CITY OF KIRKLAND

MEMORANDUM

Subject: TOUCHSTONE (PARKPLACE), ORNI, AND ALTOM PRIVATE AMENDMENT REQUESTS (PARs) FILE NO. ZON07-00016, ZON07-00012, AND ZON07-00019

Figure 1. Effect of Monthly Downtown Parking Price on SOV Share

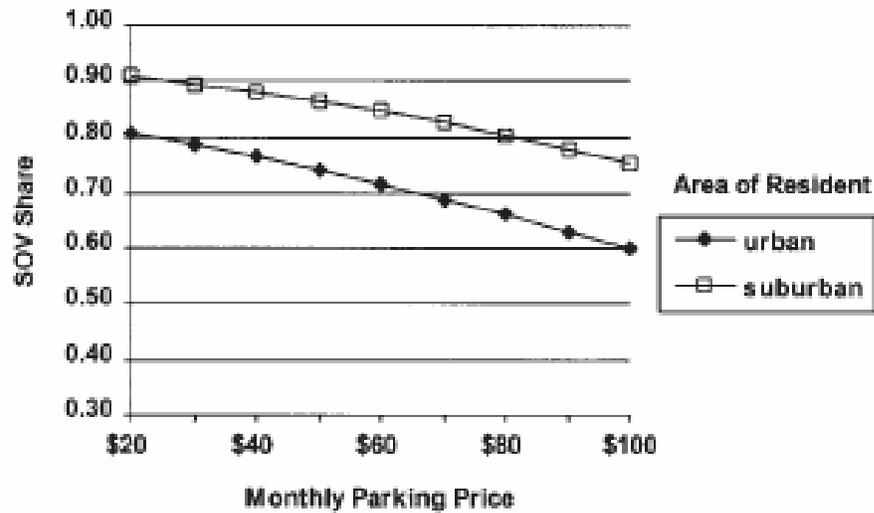
Comment 2. *Provide evidence of the price effect on the office parking demand.*

Response: Research supports the notion that the price of parking is the most important factor in increasing transit usage. A Transportation Research Board report, *Strategies that Attract Auto Users to Public Transportation*¹ states, “Cities with restrictive parking practices, including higher parking prices, tend to have better transit service and higher transit ridership rates. Change in factors related to parking price have a stronger effect on mode choice than do factors related to transit service.” It also states that, “increasing parking prices for employees is more effective in reducing SOV travel than any of the other pricing strategies examined.” The chart below was excerpted from this report, although it reflects an urban work location, it shows that the price of parking does have a positive effect in reducing SOV travel.

Figure 2. Seasonal Fluctuation in Parking Demand

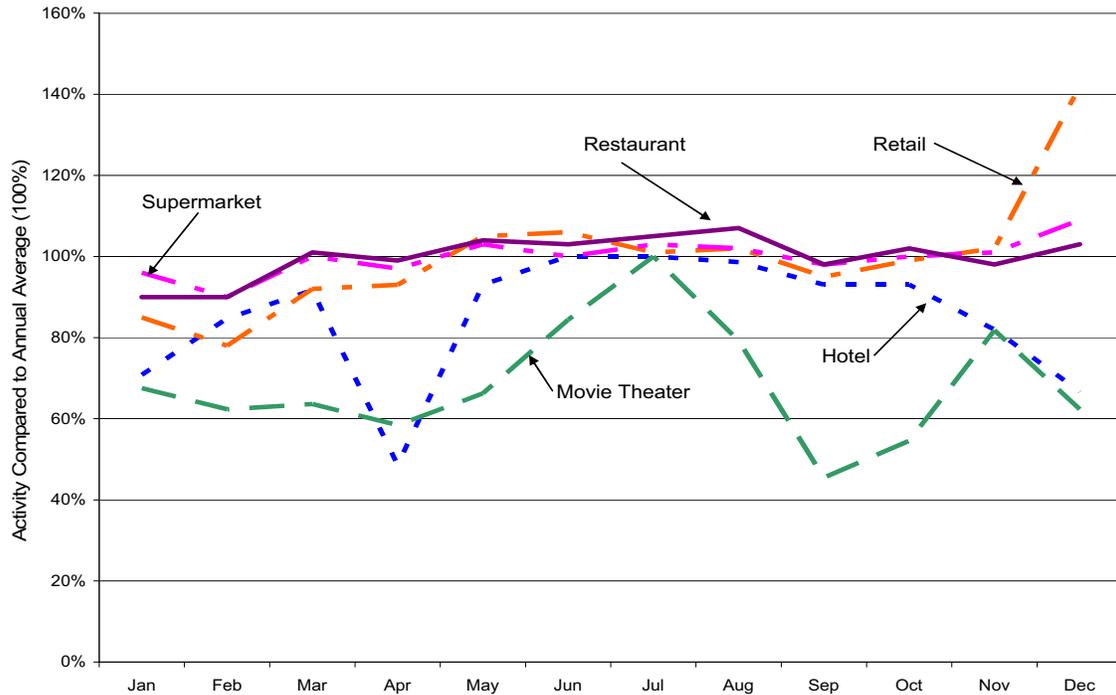
Comment 4. The applicant should provide more evidence of frequency of peaking and appropriate occupancy rates so that parking congestion does not occur more than thirty (30) hours per year.

Response. The individual land uses at Parkplace will have peak parking demand that varies by time of day, day of week and season of year. Figure 2 shows how parking rates for various land uses change month to month. These data, from the Institute of Transportation Engineers' (ITE) *Parking Generation*, reflect how the parking rates compare to the average parking rate. This shows that the peak activity for restaurants, the movie theater and the hotel occurs in the summer. Movie theater activity reaches its maximum peak on the day after Thanksgiving and during the week between Christmas and New Year. However, these are holidays when office parking demand is low.

Retail activity spikes from mid-November to mid-December. During this season, movie theater activity and hotel activity are lower than normal. Anecdotal information suggests that health club activity drops in December (it then peaks in January). There is also no seasonal activity data available for office uses. However, parking demand tends to be lowest during peak vacation periods in the summer and around the holidays.

The data show that the highest parking demand is likely to occur in December when the supermarket and retail activity increases to its highest level of the year. Retail peaks that occur midday on weekday are expected to be very limited; the highest retail demand is still likely to occur in the evenings and on weekends when most office parking on the site would be available for customers.
